From: Kevin Eaton [REDACTED]
Sent: 10 December 2021 15:40
To: Kathryn Welch <Kathryn.Welch@arun.gov.uk>
Subject: Re: Flint Barn K/49/21/HH

A - Front (North) dormer - The 'as-built' dormer is approx' 350mm higher than the original (application). The current application was submitted primarily to regularize this non-compliance with the original approved proposal.

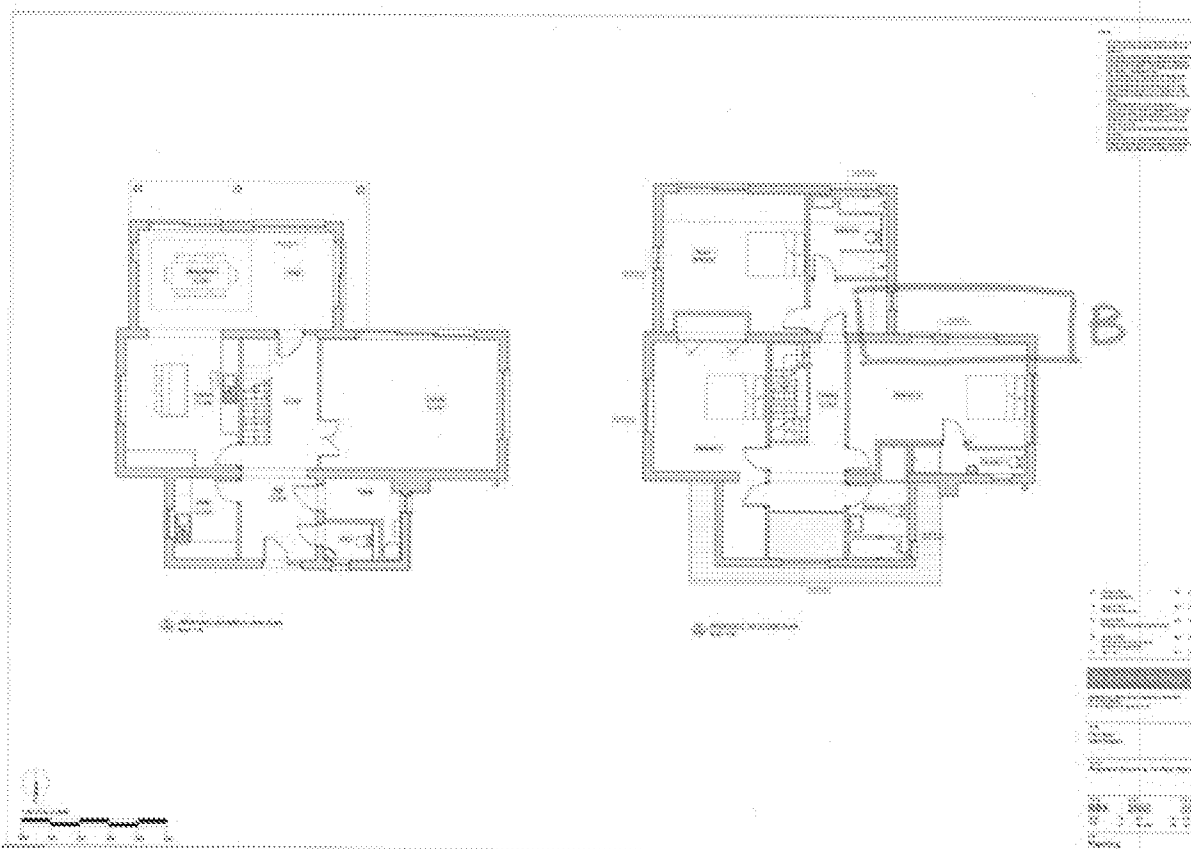
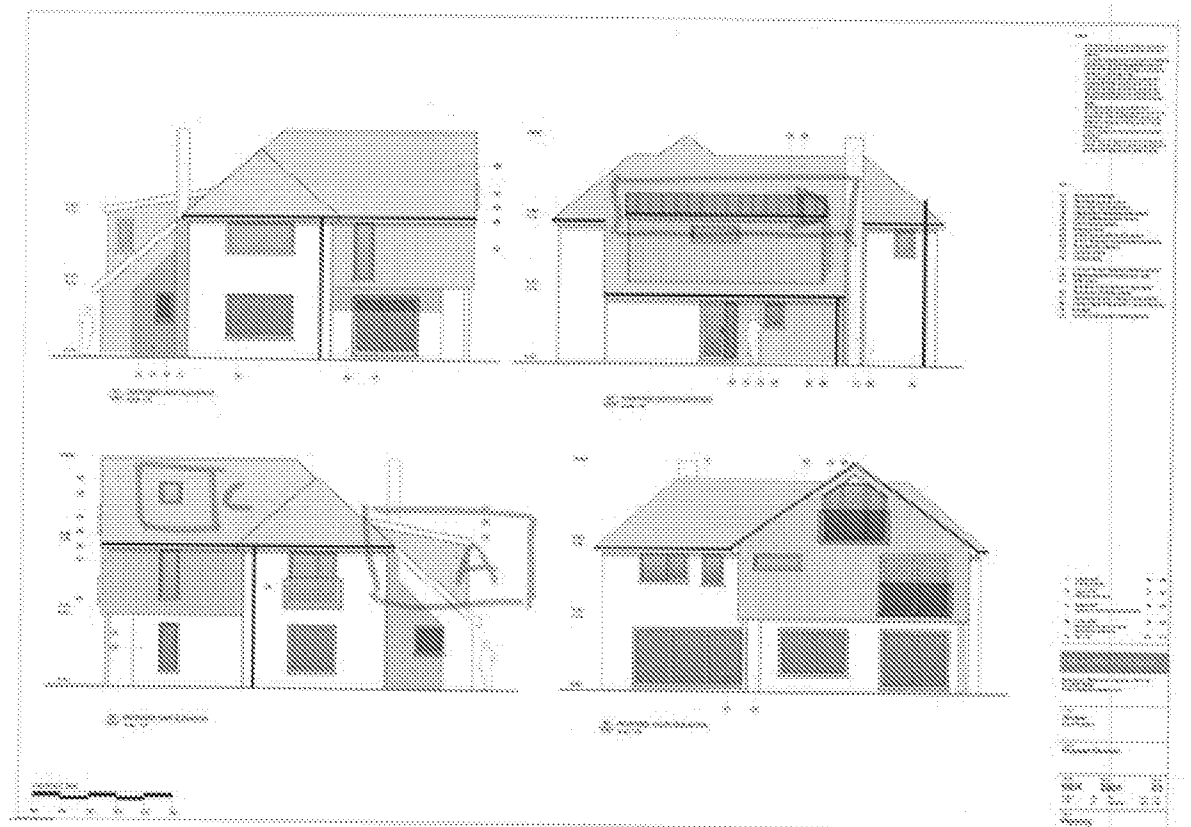
In the meantime I have annotated the existing drawing to show the balcony (although I cannot guarantee the accuracy of the scale). This is attached at the end of this e-mail.

I would be grateful if you could amend the plan showing the juliette balcony on the eastern elevation to bedroom 3, if this is what is going to be/has been built.

B - Rear first floor corridor extension - Part of original approved plan but omitted from this application as no longer required.

C - East Elevation Roof Velux - proposed in this application. Fitted in lieu of the roof Velux on the south elevation roof which was agreed in the approved application but has now has been removed.

D - Roof Covering to new (North) dormer - As built roof covering is a folded lead effect GRP roof finish. This was originally a clay tile roof covering in the approved plan but due to the change in roof pitch on the 'as-built' dormer (see A), the tile was not compatible - hence the necessity to change the design and material.
